# MEMORANDUM

**TO:** Planning Board Members  
**FROM:** Michael A. Lumbis, Planning and Community Development Director  
**PRIMARY REVIEWER:** Geoffrey T. Urda, Planner  
**SUBJECT:** Site Plan Approval – 155 Clinton Street  
**DATE:** June 1, 2023  
**Request:** Site Plan Approval to construct a 2,378 SF building addition, a 253 SF building addition and a 9,500 SF sq. ft. parking lot expansion at **155 Clinton Street**, Parcel Number 10-07-109.100  
**Applicant:** Design Build Innovations, LLC  
**Proposed Use:** Professional Office Building  
**Property Owners:** Clinton Center Development, LLC

**City of Watertown**  
**SITE PLAN APPROVAL APPLICATION FORM**

Clinton Center Redevelopment  
Multi-Tenant Professional Office Building  
155 Clinton Street  
Watertown, NY 13601

SHEET TITLE:  
ELEVATION VIEWS

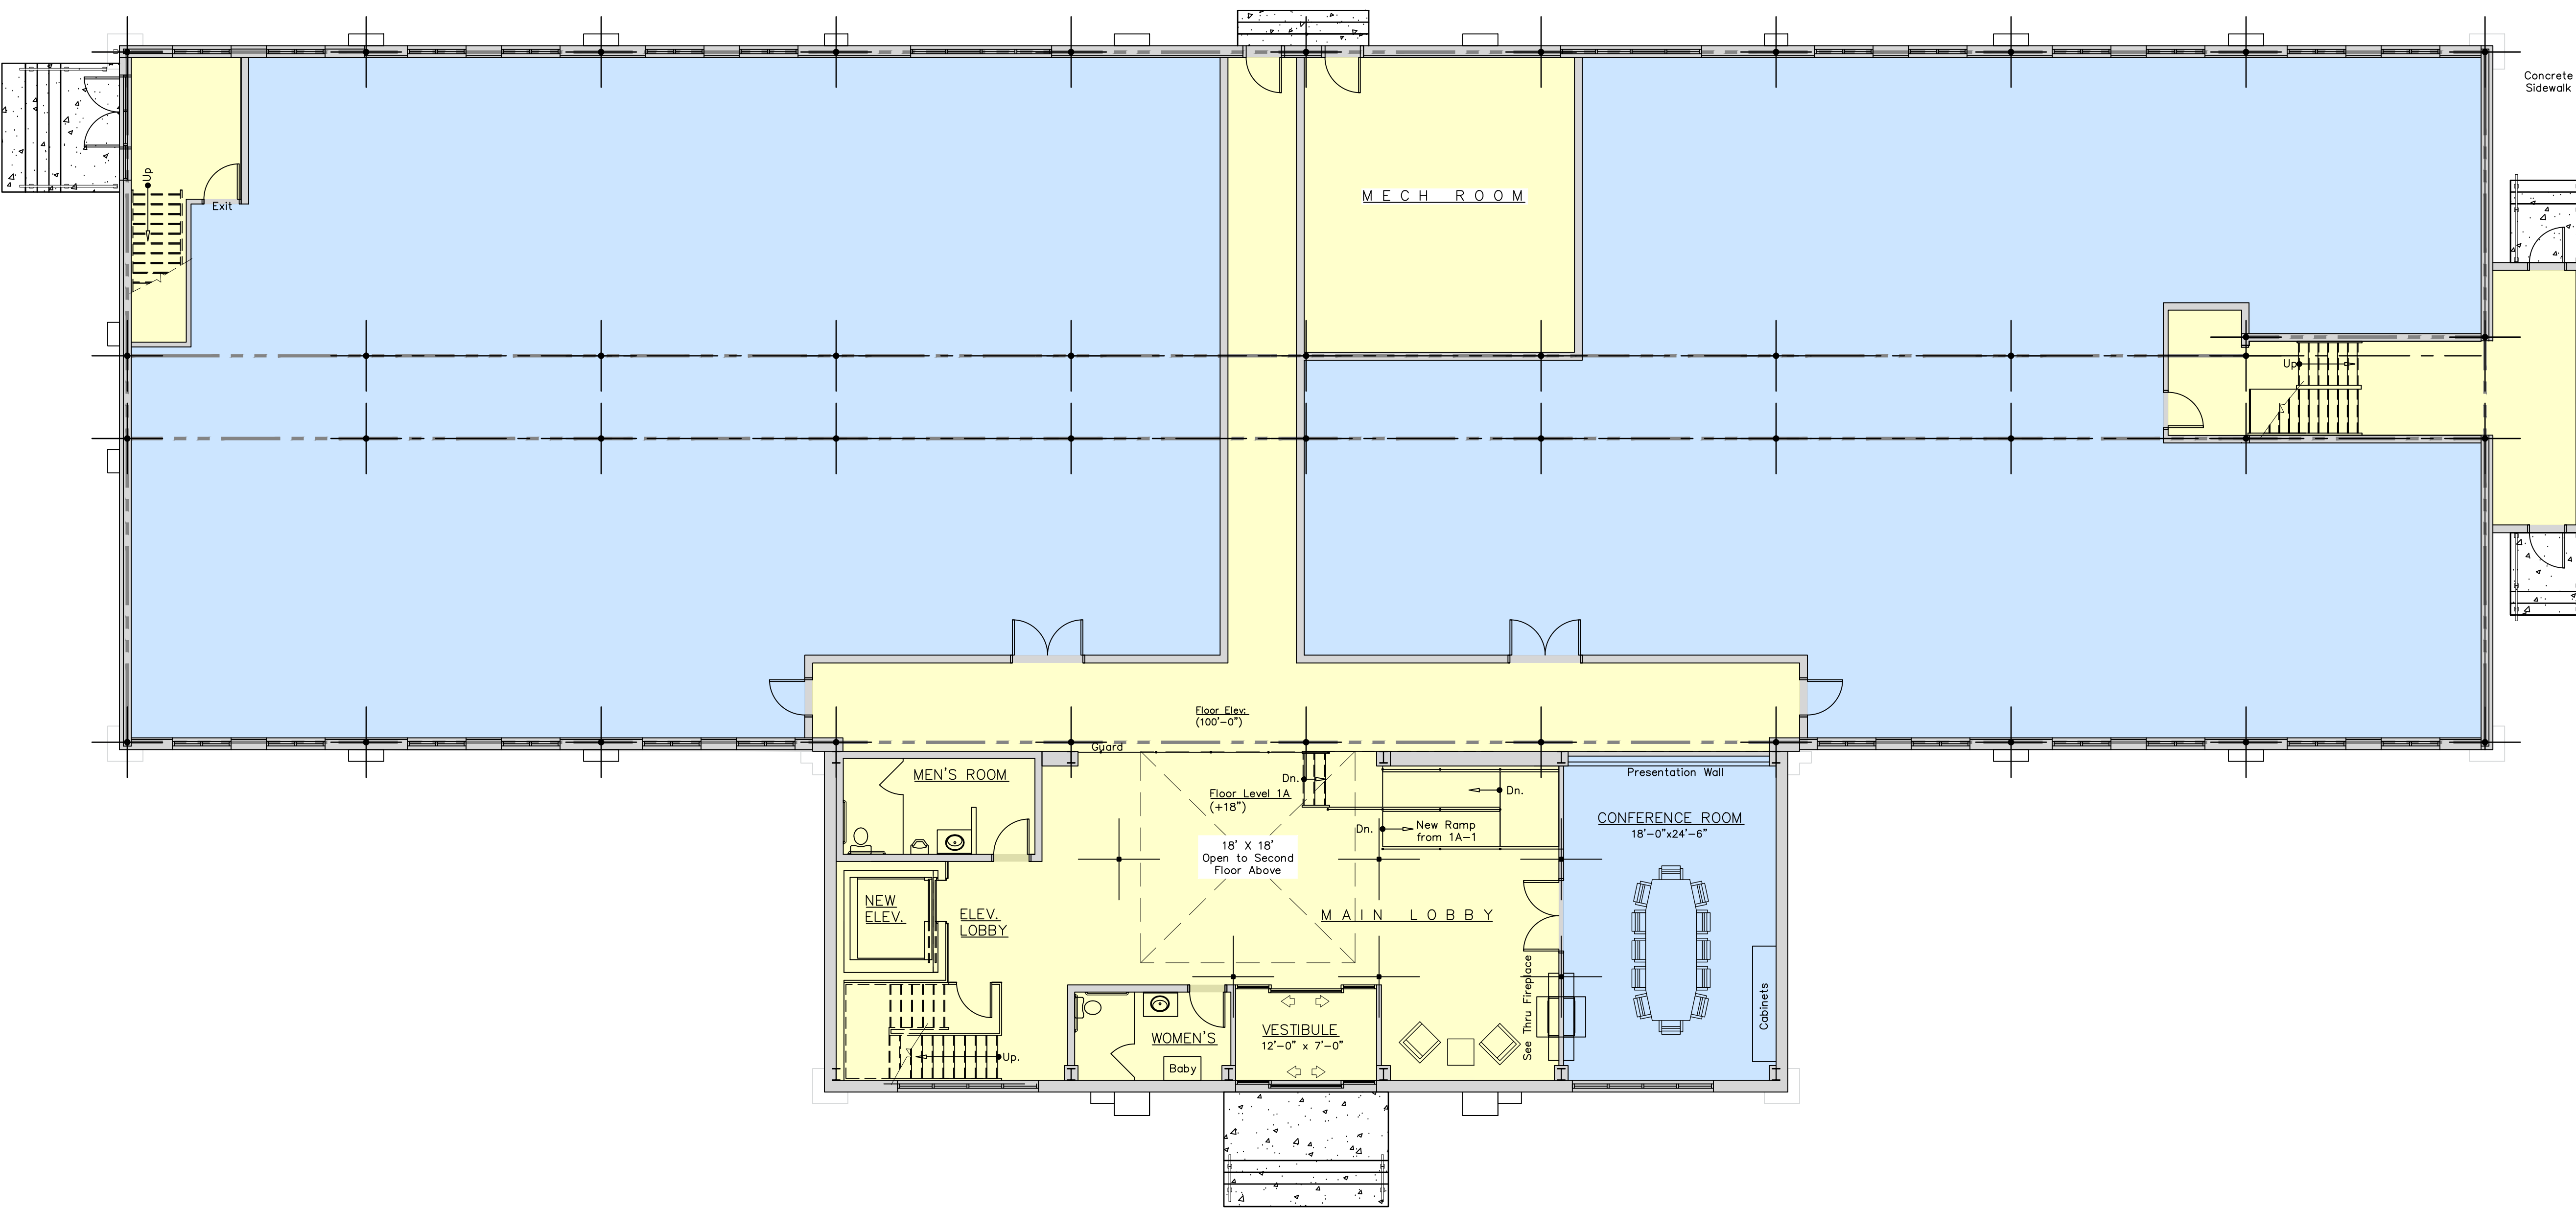
The applicant did not include transparency calculations with the submitted elevation drawings. However, the applicant is responsible for submitting those calculations, and if the applicant seeks less transparency than the Zoning Ordinance requires, then such a reduction in transparency could only be legal with the relief of an Area Variance granted by the Zoning Board of Appeals. While the applicant did not include transparency calculations, it is evident from a cursory review of the elevation drawings that the ground-floor requirements are not being met.

First-floor transparency in particular is a core urban design principle when attempting to cultivate a pedestrian-oriented setting. Thus, the 75 percent ground floor transparency requirement Downtown, which is higher than any other Zoning district in the City.

1. The applicant shall submit transparency calculations for the proposed building facades and must either increase transparency levels to meet the requirements of the Zoning Ordinance or apply for and obtain an Area Variance from the Zoning Board of Appeals granting relief from the requirements.
